STATEMENT THAT A PROPOSAL MAY BE IMPLEMENTED (PURSUANT TO THE PROVISIONS OF THE ENVIRONMENTAL PROTECTION ACT 1986)

METROPOLITAN REGION SCHEME AMENDMENT - EXTENSION OF THE KWINANA FREEWAY RESERVE FROM THOMAS ROAD, KWINANA TO THE MRS BOUNDARY

Attachment to Statement 69 - Change to Description of Proposal.

Attachment 2 to Statement 069

Figure 4:

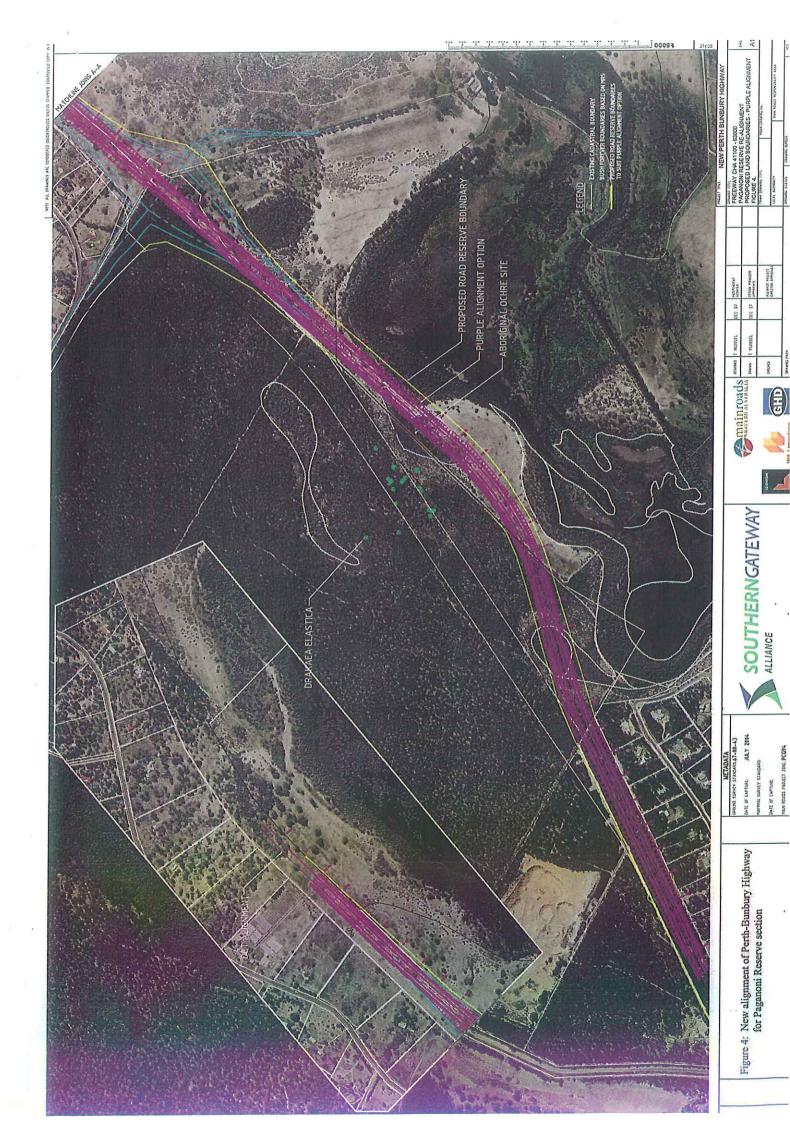
Change:

Realignment of the Perth-Bunbury Highway for the Paganoni

Reserve Section as shown in Figure 4

From:

Element	Quantities/Description
Paganoni Reserve area alignment	Up to 110m west into Paganoni Reserve from that shown in Figure 3.

To:

Element	Quantities/Description
Paganoni Reserve area alignment	Alignment of the Perth-Bunbury Highway for the Paganoni Reserve Section as shown in Figure 4.

Figure 4: New alignment of Perth-Bunbury Highway for Paganoni Reserve section

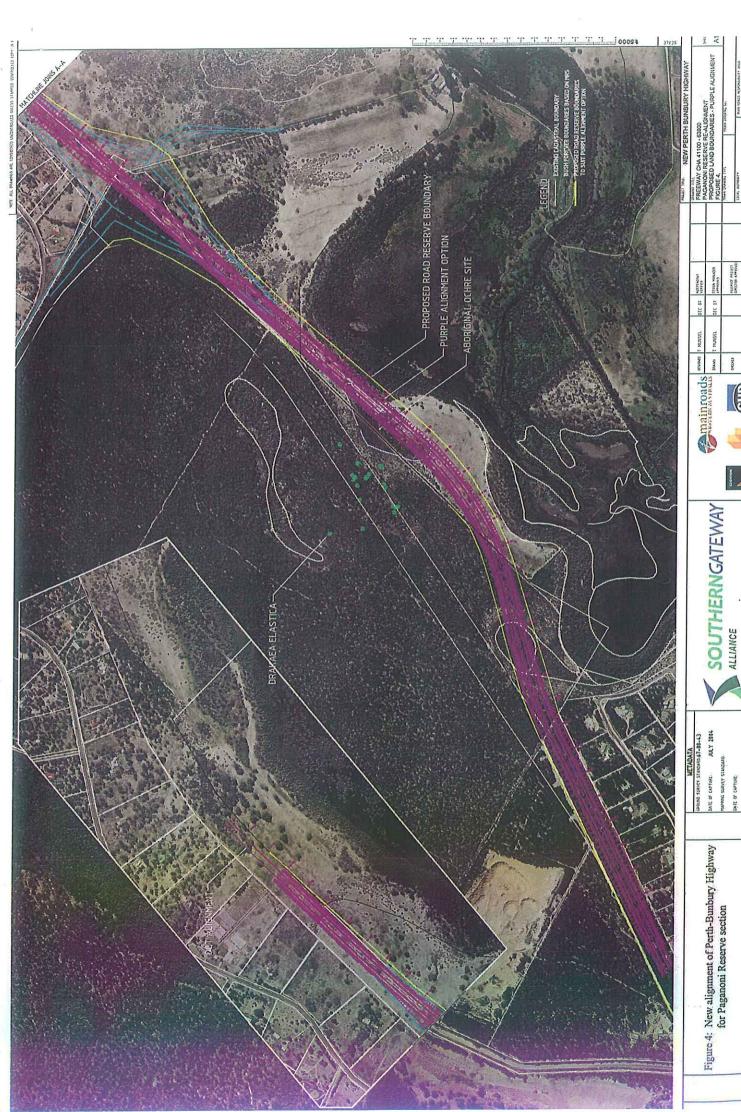
Change:

Realignment of the Perth-Bunbury Highway for the Paganoni

Reserve Section as shown in Figure 4

From:

Element	Quantities/Description
Paganoni Reserve area alignment	Up to 110m west into Paganoni Reserve from that shown in Figure 3.

To:

Element	Quantities/Description
Paganoni Reserve area alignment	Alignment of the Perth-Bunbury Highway for the Paganoni Reserve Section as shown in Figure 4.
